LAND USE APPLICATION SUMMARY

Property Location: 4601 Hiawatha Ave
Project Name: Hiawatha Holiday Stationstores Rebuild
Prepared By: Shanna Sether, Principal City Planner, (612) 673-2307
Applicant: Holiday Stationstores
Project Contact: Carol Lansing
Request: To reconstruct an automobile convenience facility and accessory car wash.

Required Applications:

4 NORTHWEST ELEVATION
FACING INTERSECTION

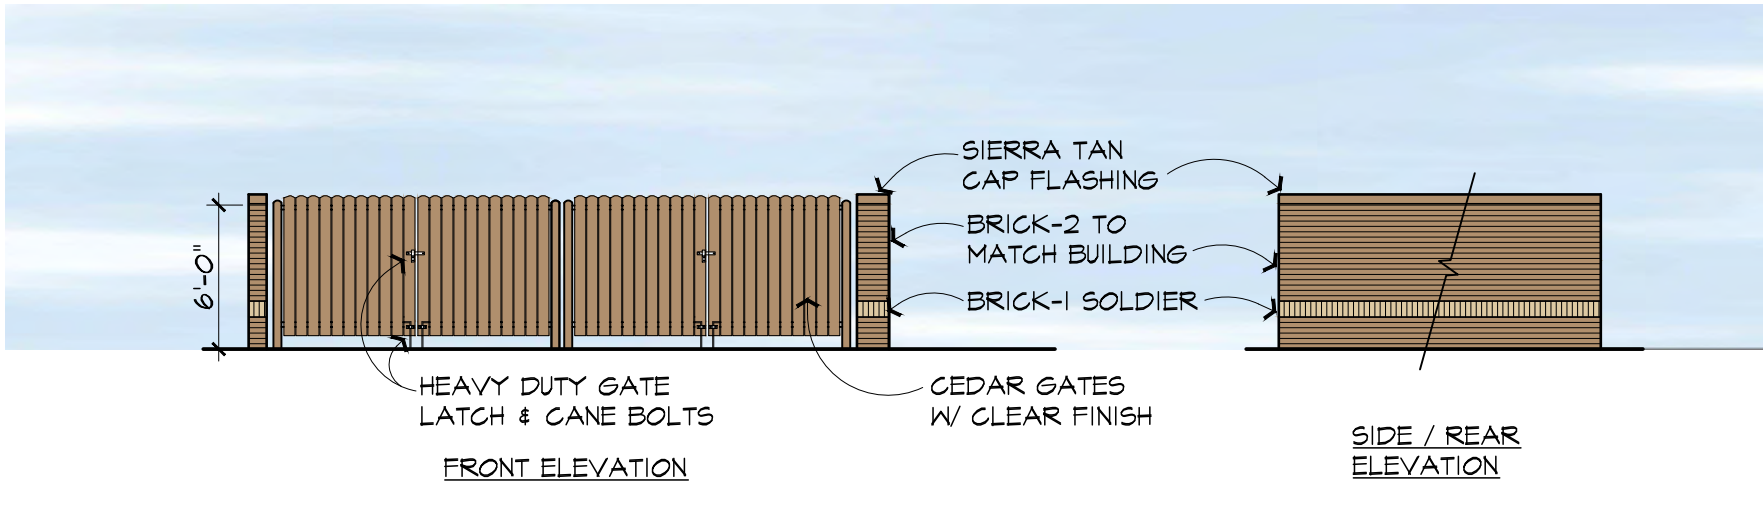
The proposed dynamic sign should not be detrimental to public health, safety, comfort or general welfare. The applicant is proposing to add a dynamic sign to a new wall sign mounted on the on the northwest corner of the property, similar to the previously approved dynamic monument sign. Dynamic signs are permitted in a PO District subject to approval of a conditional use permit unless located in the downtown entertainment area. The zoning code regulations related to dynamic signs includes specific standards adopted to address potential issues. The standards limit the location, size, height, duration of message, image characteristics and transition and the luminance. The proposed sign meets the specific standards for dynamic signs.

Staff comment: The sign will be attached to a building wall and as proposed would be nine feet, three inches to the top of the dynamic portion of the sign.

Staff comment: The dynamic sign would be 24 square feet in area.

Staff comment: The message will remain static for a minimum of 60 seconds and will transition with no special effects.

Staff comment: The sign will have a pixel spacing of 19 mm and no special effects.

Staff comment: The sign will have a maximum luminance of 5,000 nits between sunrise and sunset and 500 nits at all other times. The sign will be equipped with a light sensor and automatic dimmer control to comply with this requirement.
